APPLICATION FOR VARIANCE Curb cuts/sidewalks

NOTICE OF ACTION

Starbucks ' 411 Massachusetts Ave

Re: Starbucks Coffee, 411 Massachusetts Ave Acton Ma

G-002

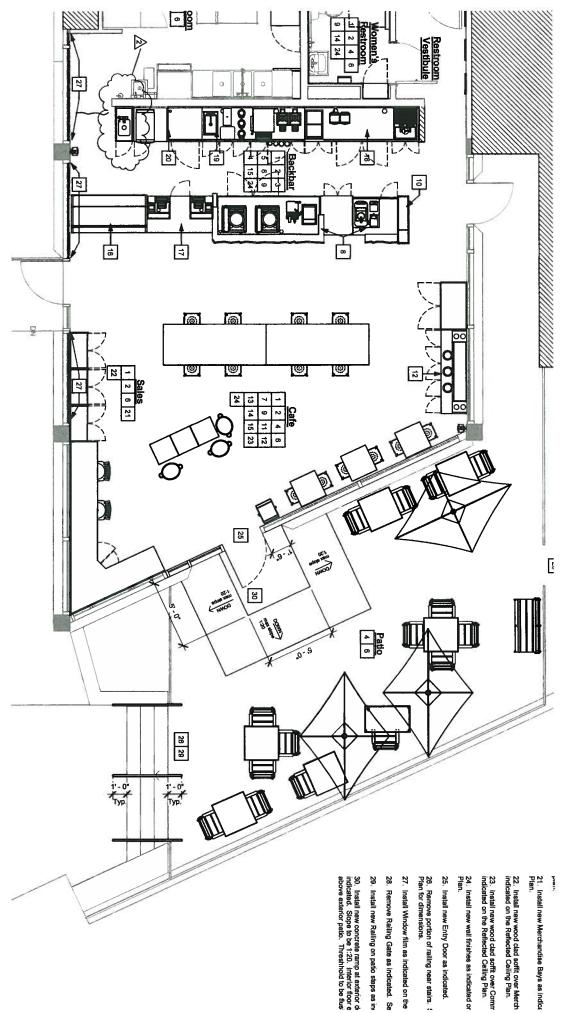
On May 24, 2013 Daniel Brennen Jr. of dpb Consulting Services submitted a letter and plan. The plan, sheet # G-002, issue date of 3/11/2013 showed that the door in question will meet the requirements of 521 CMR.

The Board voted that no variance is needed at this time, and that the removal of the barrier (gate) at the top of the stairs so the stairs may be used as a path of travel is allowed.
